CONSOLIDATED EDISON COMPANY OF NEW YORK, INC.
INDIAN POINT NUCLEAR GENERATING UNIT NO. 3

FIRST SUPPLEMENT TO:
PRELIMINARY SAFETY ANALYSIS REPORT

PREFACE TO QUESTIONS

Supplement 1 of the Indian Point Unit No. 3 PSAR consists of responses to the Atomic Energy Commission's letter of February 19, 1968, and July 1, 1968.

SAFETY INJECTION SYSTEM
FIGURE 1
SUPPLEMENT 1

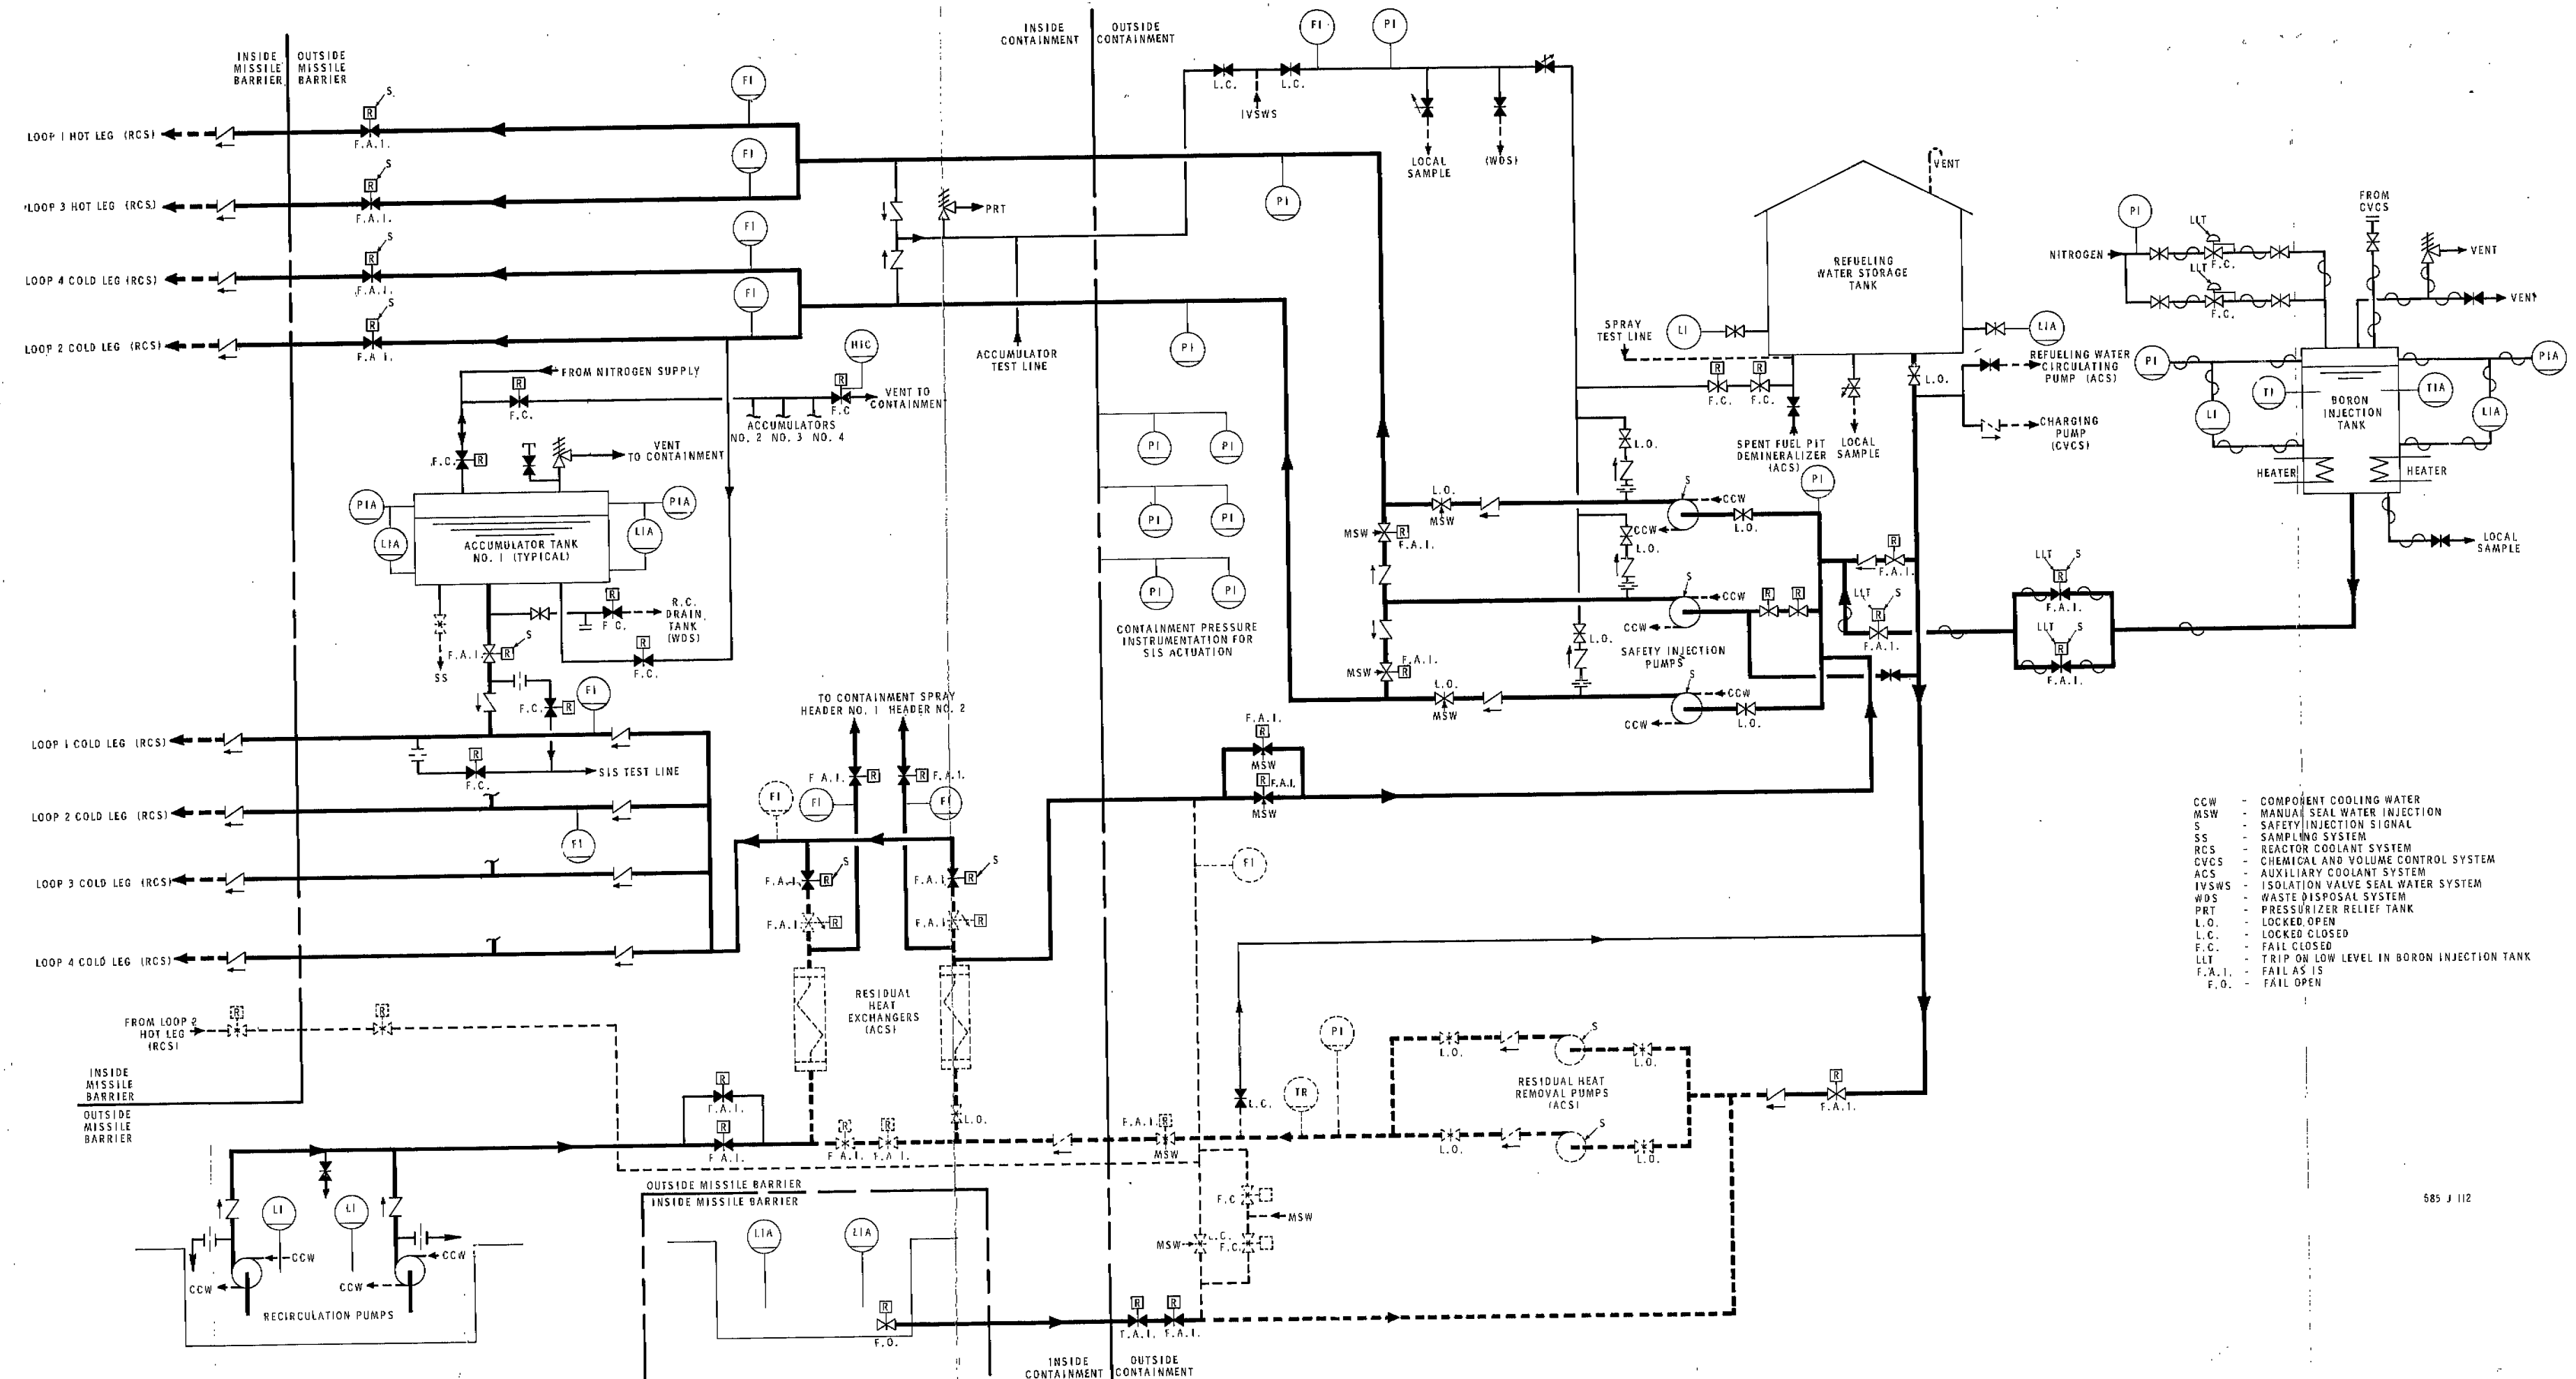
The energy removal from the Reactor Coolant System following a steam line rupture causes a reduction of coolant temperature which in turn results in a reduction of the coolant volume and a reduction in system pressure. The reduction in coolant volume causes the pressurizer to empty within the first few seconds. The subsequent addition of the highly borated water by the Safety Injection System renders the core subcritical before the water level is re-established in the pressurizer. The boric acid injection tank is shown in Figure 1 for the revised process flow diagram of the Safety Injection System.

FIGURE A.1-10
STEAM FLOW THRU FOUR LOOPS (LBS/SEC)

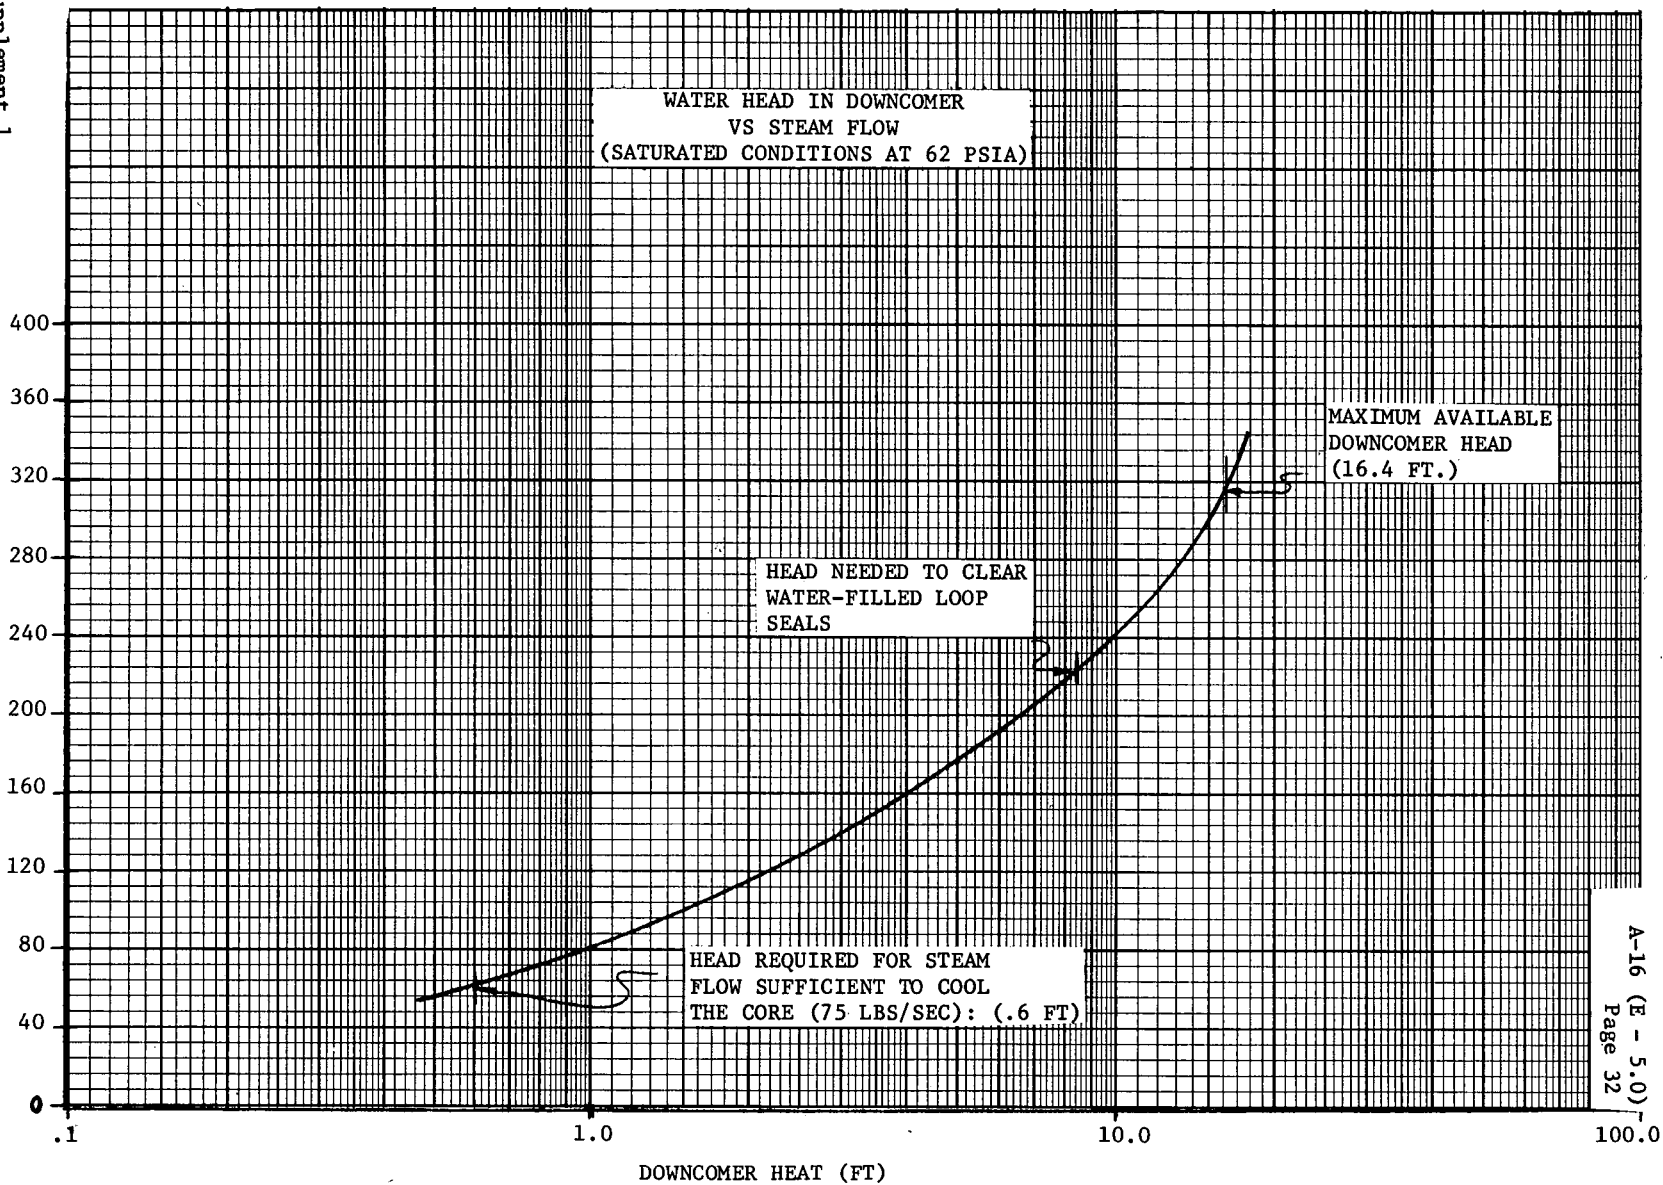
The relationship between this downcomer head and corresponding steam flow rate through the loops is shown in Figure A.1-10. The resistance to steam flow used for this curve is based on the resistance of the loop piping, steam generators and pumps (assuming the expected condition of empty loop seals) and a saturation pressure of 62 psia at the completion of blowdown.

FIGURE A.1-11

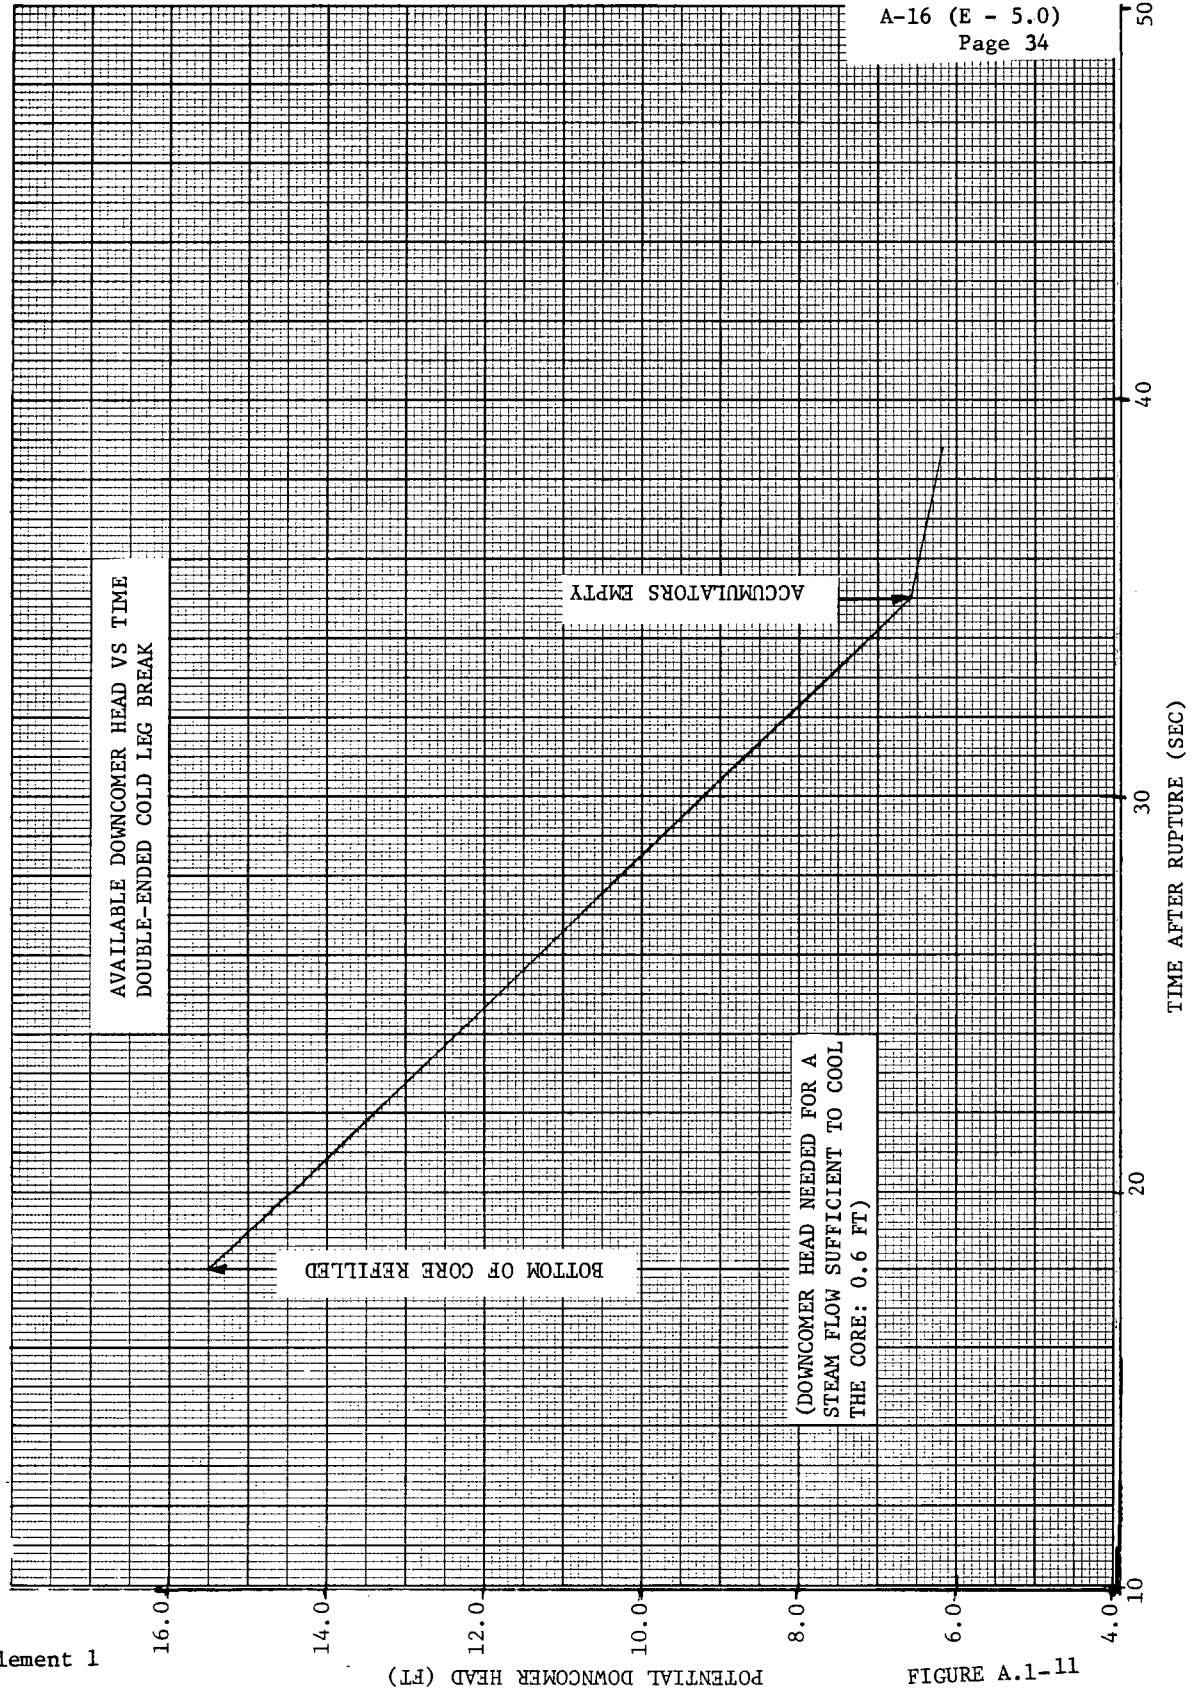
The available downcomer head during the refilling of the core for the double-ended cold leg break is shown in Figure A.1-11. Comparison of this available head to the head needed for a steam flow sufficient to cool the core shows the considerable margin in potential steam driving head.

FIGURE A.2-5

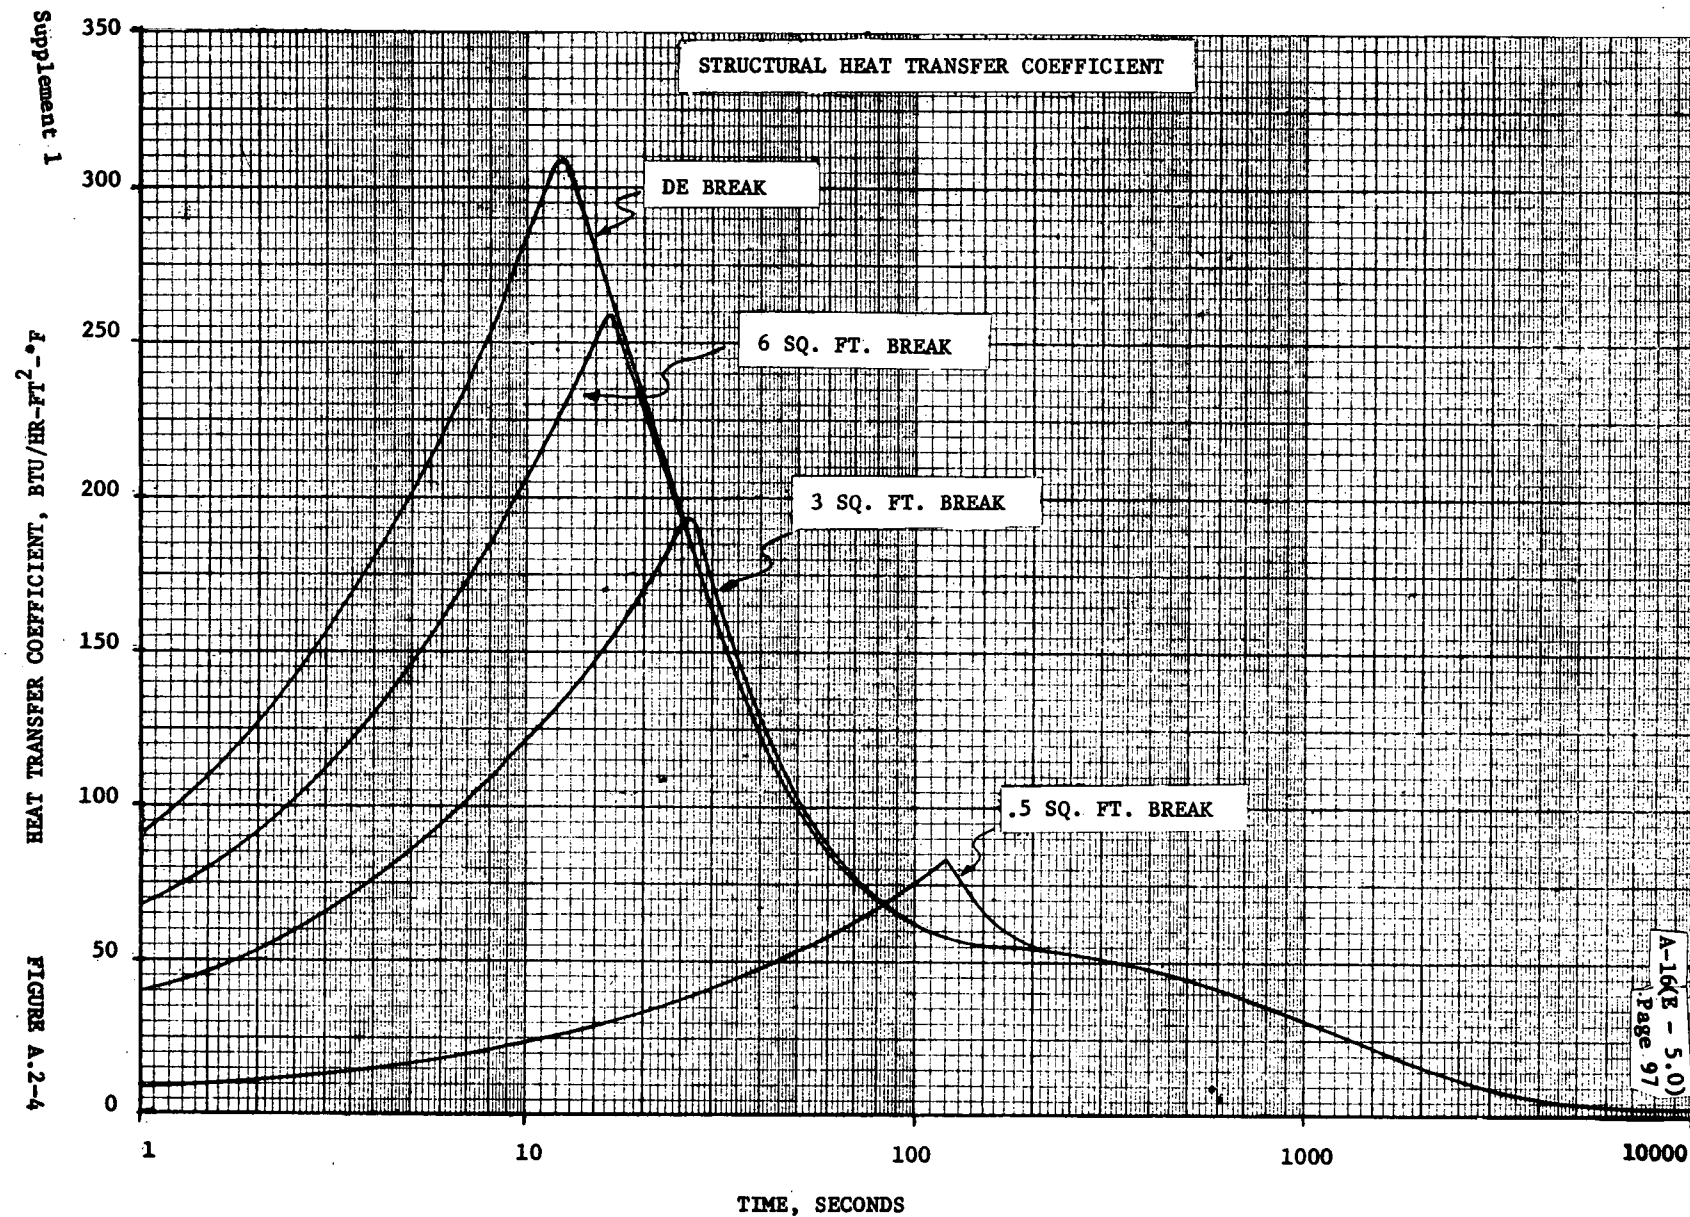
Point A in Figure A.2-5 corresponds to the internal energy at the end of a 3 ft² break blowdown, 258 x 10⁶ Btu. In order for the pressure to increase to design pressure (47 psig) the internal energy must be increased to 306 x 10⁶ Btu (Point B). The allowed energy addition is therefore 48 x 10⁶ Btu. Since energy transferred to the containment from the core is in the form of steam the total transferred core energy corresponding to allowed energy addition is as follows:

Line A to C on Figure A.2-5 represents a constant mass line extended into the superheated region. Comparison of the energy addition allowable for the superheated case relative to the saturated case shows a lesser ability of the containment to absorb an equivalent amount of energy as superheat. An addition of 13×10^6 Btu of energy after blowdown would cause the containment pressure to increase to design. The recombination of hydrogen and oxygen from a 14.6% Zr-H₂O reaction completed before the end of blowdown would be required to generate 13×10^6 Btu's of energy. For the case analyzed, the core was assumed to be in a subcooled state, and no Zr-H₂O reaction would be possible. In order for Zr-H₂O reaction to occur before the end of blowdown all of the stored initial energy must remain in the core. If this occurred a blowdown peak containment pressure of only 34.2 psig would be reached instead of 39.5 psig in the case analyzed. Lines D and E on Figure A.2-5 represent the superheat energy addition required to increase the pressure to the design pressure and this corresponds to the hydrogen oxygen recombination energy from a 24.6% Zr-H₂O reaction.
